Bryant Development and Review Committee Meeting

Date: November 26, 2025 - **Time:** 9:00 AM

5. 6128 Hwy 5 - Site Plan - Lot 22R of Marketplace II Subdivision Ph3

CONSTRUCTION PLANS
MARKET PLACE II
6128 HIGHWAY 5, BRYANT, SALINE COUNTY, AR

DATE: 11.11.25	C.A.D. BY:		DRAWING NUMBER:
REVISED:	CHECKED BY:		25-0608
SHEET: C-2.0	SCALE:

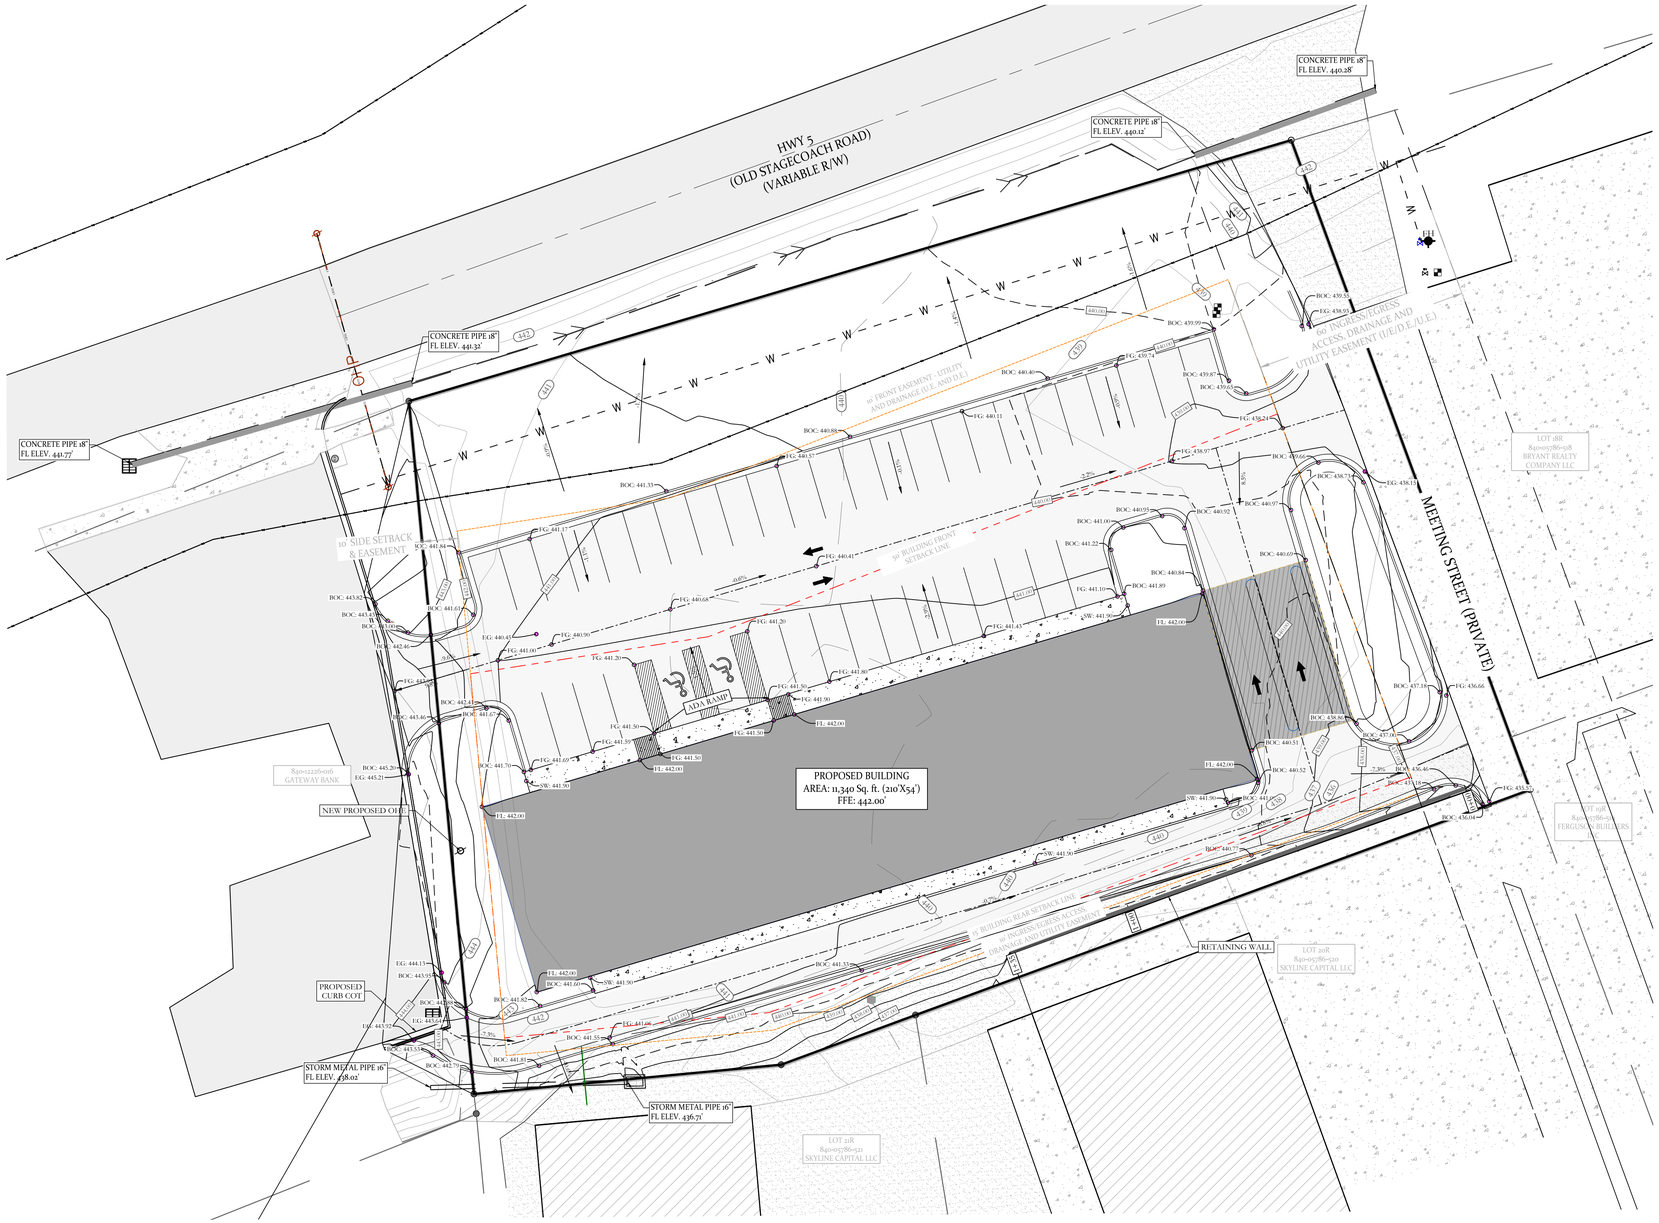
Comment no.1- Indicate grade on parking lot south entrance. Grade may not exceed 10 percent. [D103.2]

Response- The proposed and existing contours are shown in sheet C-2.0 with different styles.

Response- The contours are labeled in sheet C-2.0.

Response- The grade will not exceed 10% in south entrance. See sheet C-2.0
